(1) **THIRD FLOOR PLAN**
SCALE: 1/4" = 1'-0"

CALVARY CHAPEL OF THE REDWOODS

EXISTING FACILITY CODE REVIEW
3160 S. FRED HAIGHT DRIVE
SMITH RIVER
CALIFORNIA

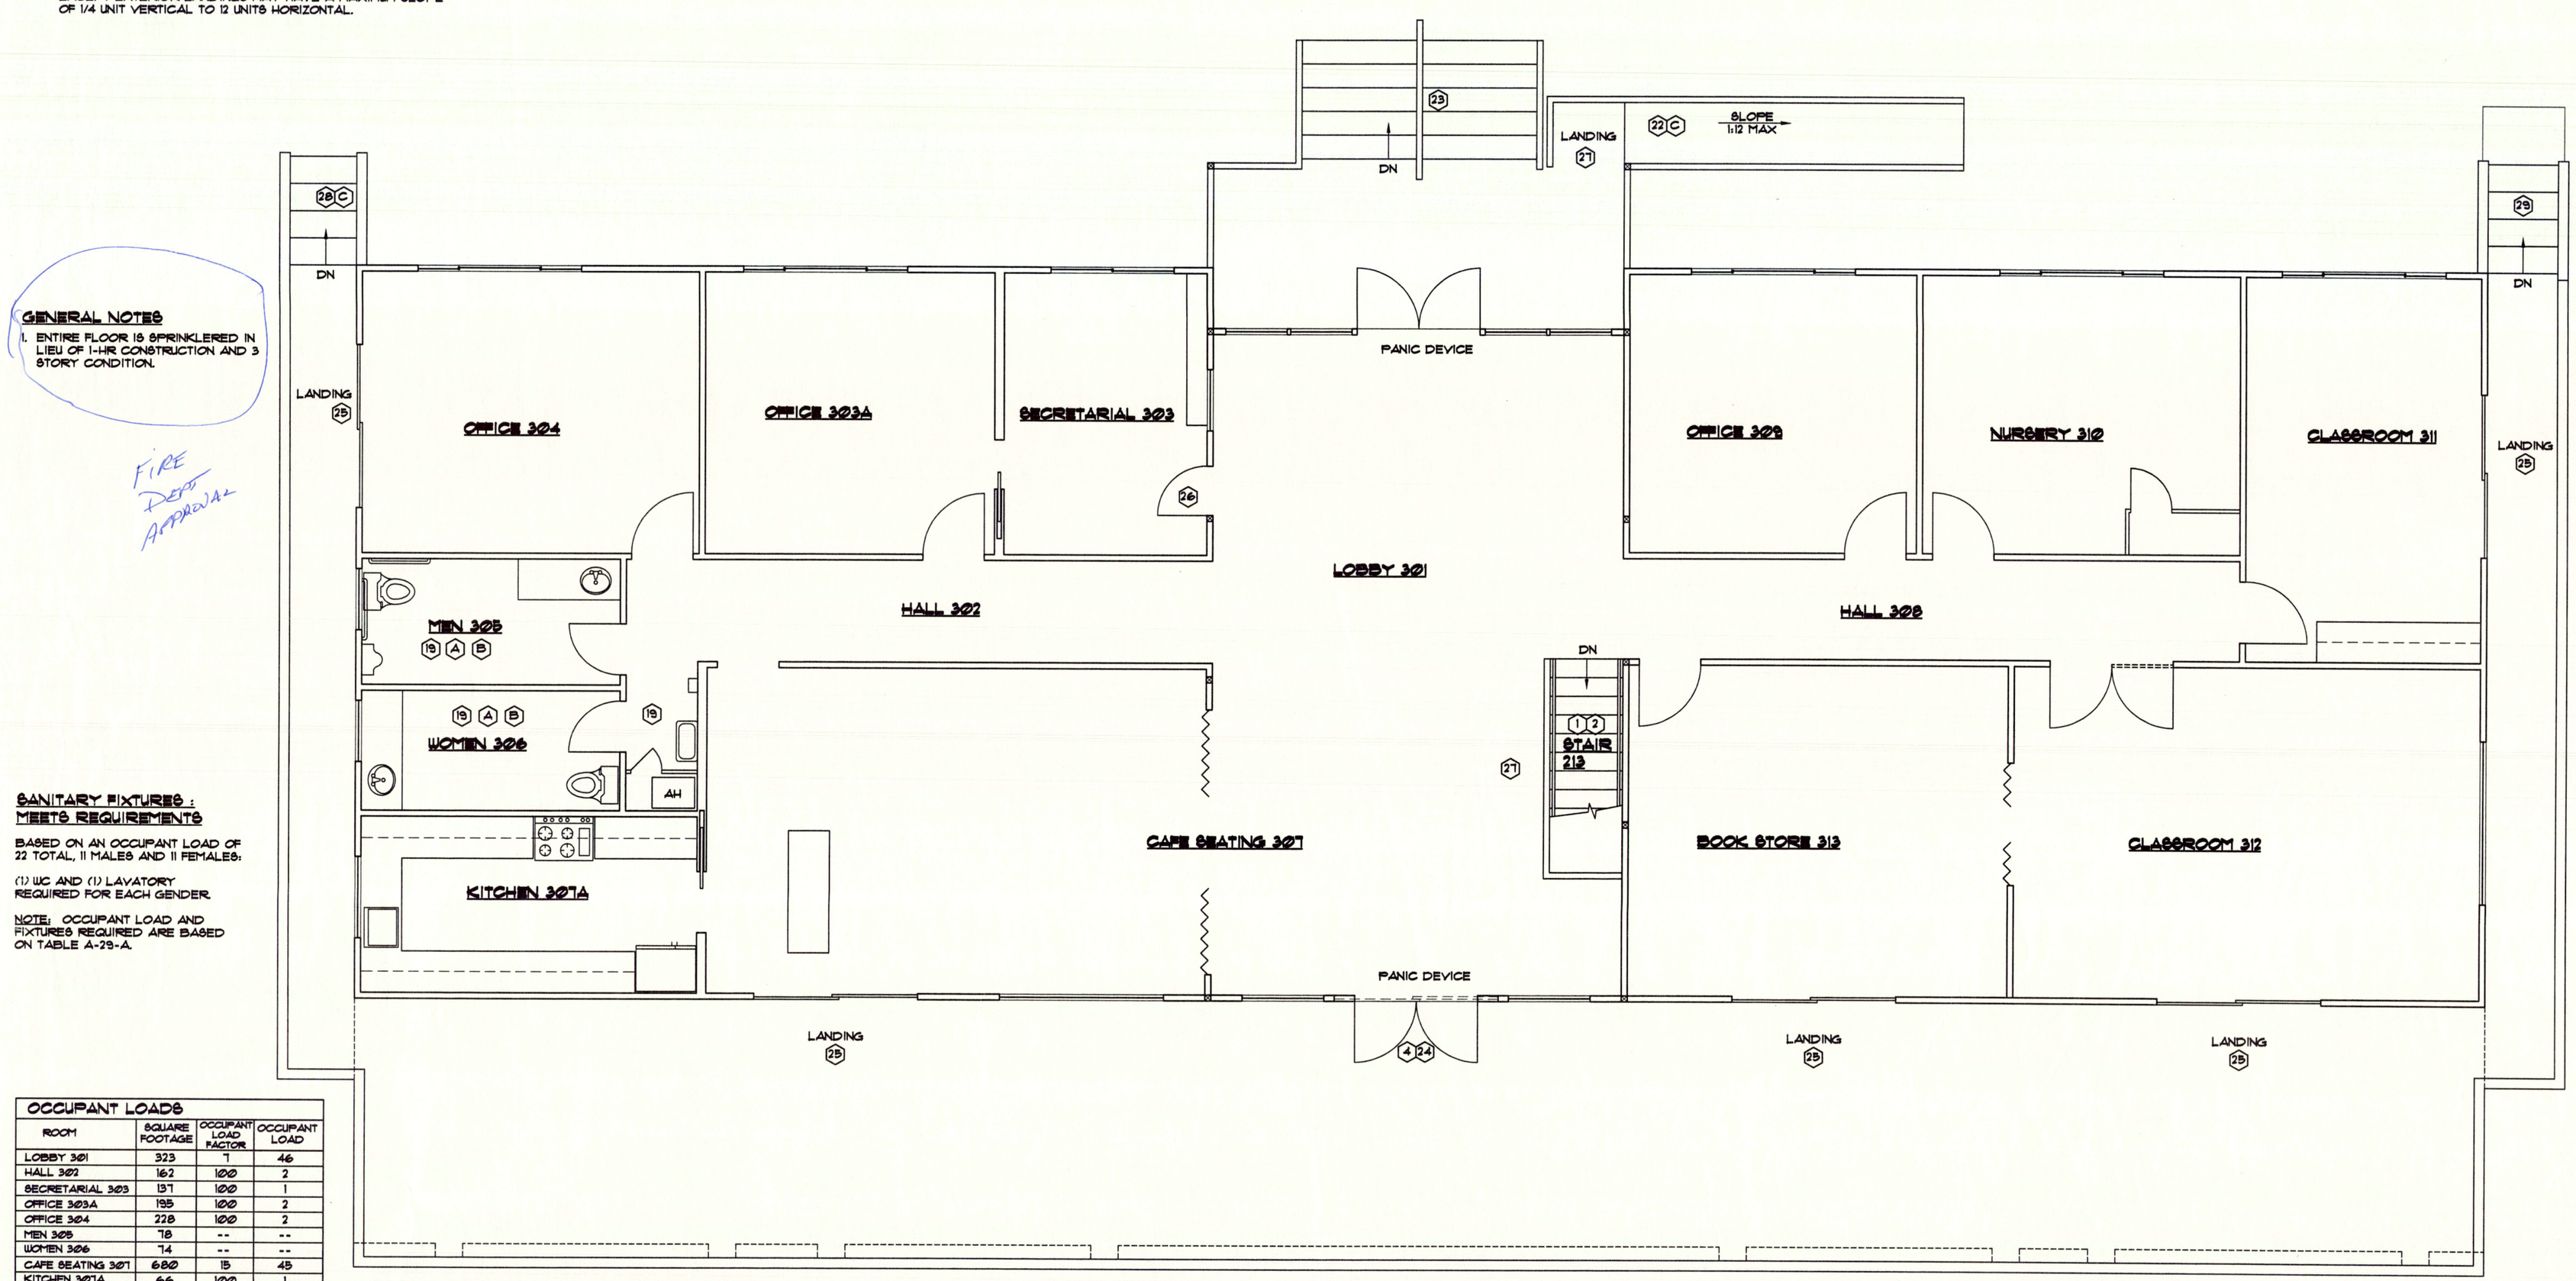
(1) **STAIRS** (SECTION 1003.3.3)
FIRST FLOOR TO SECOND FLOOR: CLEAR STAIR WIDTH IS 43½", WHICH IS ½" LESS THAN THE MINIMUM STAIR WIDTH REQUIRED OF 44". AVERAGE RISER HEIGHT IS 7⅛", WHICH IS ⅛" HIGHER THAN THE MAXIMUM OF 7". THE TREAD DEPTH OF 11" MEETS THE CODE REQUIREMENT.
SECOND FLOOR TO THIRD FLOOR: CLEAR STAIR WIDTH IS 41½", WHICH IS 2½" LESS THAN THE MINIMUM STAIR WIDTH REQUIRED OF 44". AVERAGE RISER HEIGHT IS 7⅜", WHICH IS ¾" HIGHER THAN THE MAXIMUM OF 7". THE TREAD DEPTH OF 11¼" MEETS THE CODE REQUIREMENT.

(2) **HANDRAILS @ STAIRS** (SECTION 1003.3.3.6)
EXISTING HANDRAIL DOES NOT MEET CODE REQUIREMENTS, WHICH ARE AS FOLLOWS:
- ONE HANDRAIL ON EACH SIDE OF STAIR, MOUNTED AT BETWEEN 34" MINIMUM AND 38" MAXIMUM, MEASURED FROM LANDING AND TREAD NOSING TO TOP EDGE OF HANDRAIL.
- ONE HANDRAIL TO EXTEND 12" BEYOND TOP AND BOTTOM RISER.
- HANDRAIL ENDS TO RETURN TO THE WALL OR HAVE ROUNDED TERMINATIONS OR BENDS.

(4) **EXIT DOOR** (SECTION 1003.3.1)
EXIT DOORS TO MEET THESE REQUIREMENTS:
- MINIMUM DOOR SIZE: 3' NOMINAL WIDTH AND 6'-8" NOMINAL HEIGHT.
- FLOOR OR LANDING ON EACH SIDE OF DOOR, NOT LESS THAN ½" LOWER THAN DOOR THRESHOLD FOR ADA ACCESS, 1" MAXIMUM ELSEWHERE. FLOOR OR LANDING TO BE LEVEL, EXCEPT EXTERIOR LANDINGS MAY HAVE A MAXIMUM SLOPE OF 1/4 UNIT VERTICAL TO 12 UNITS HORIZONTAL.
- TYPE OF LOCK OR LATCH: EXIT DOORS SHALL BE OPERABLE FROM THE INSIDE WITHOUT THE USE OF A KEY OR ANY SPECIAL KNOWLEDGE. EXCEPTION: KEY LOCKING HARDWARE MAY BE USED, PROVIDING THERE IS A VISIBLE, LEGIBLE SIGN ON OR ADJACENT TO THE DOOR, STATING "THIS DOOR MUST REMAIN UNLOCKED DURING BUSINESS HOURS."
- PANIC HARDWARE: WHERE USED, ACTIVATING MEMBER MOUNTED BETWEEN MINIMUM 30" AND MAXIMUM 44" ABOVE THE FLOOR.

(18) EXISTING TOILET ROOM AND HALL ARE NOT HANDICAP COMPLIANT

(22) REMOVE EXISTING RAMP AND PROVIDE ADA COMPLIANT RAMP.

(23) **INTERMEDIATE HANDRAIL** (SECTION 1003.3.3.6)
PROVIDE INTERMEDIATE HANDRAIL. FOR INFORMATION, REFER TO KEYED NOTE (2)

(24) **SLIDING DOOR** (SECTION 1003.3.1.6)
SLIDING DOOR CANNOT BE USED AS AN EXIT DOOR AND TWO EXITS ARE REQUIRED FROM THIS FLOOR LEVEL. REMOVE SLIDING DOOR AND REPLACE WITH HINGED DOORS. REFER TO KEYED NOTE (4) FOR EXIT DOOR REQUIREMENTS.
PROVIDE LANDING AND RAMP. LANDING LEVEL TO BE MAXIMUM ½" BELOW DOOR THRESHOLD.

(25) **FLOOR LEVEL @ DOORS** (SECTION 1003.3.1.6)
PROVIDE LANDING AT EXTERIOR DOORS TO WEST DECK. LANDING LEVEL TO BE MAXIMUM 1" BELOW DOOR THRESHOLD.

(26) DOOR WIDTH NOT ADA COMPLIANT

(27) **GUARDRAILS** (SECTION 509)
GUARDRAILS REQUIRED ON OPEN SIDE OF FLOOR, MINIMUM 42" ABOVE FINISHED FLOOR W/ MAXIMUM 4" OPENINGS.

(28) **ADA REQUIREMENT.** ACCESSIBILITY AND EXITING
STAIR WIDTH OF 39" AND DECK WIDTH OF 36" DO NOT MEET MINIMUM REQUIRED WIDTH OF 44".
REMOVE EXISTING STAIR AND REPLACE WITH NEW RAMP.

(29) **STAIRS** (SECTION 1003.3.3)
STAIR AND DECK WIDTH OF 41" DO NOT MEET MINIMUM REQUIRED WIDTH OF 44", ON BOTH SIDES OF STAIR, PROVIDE HANDRAIL. FOR ADDITIONAL INFORMATION ON HANDRAILS, REFER TO KEYED NOTES (2)

EXITS REQUIRED - 2 REQUIRED - SEE KEYNOTE (24)
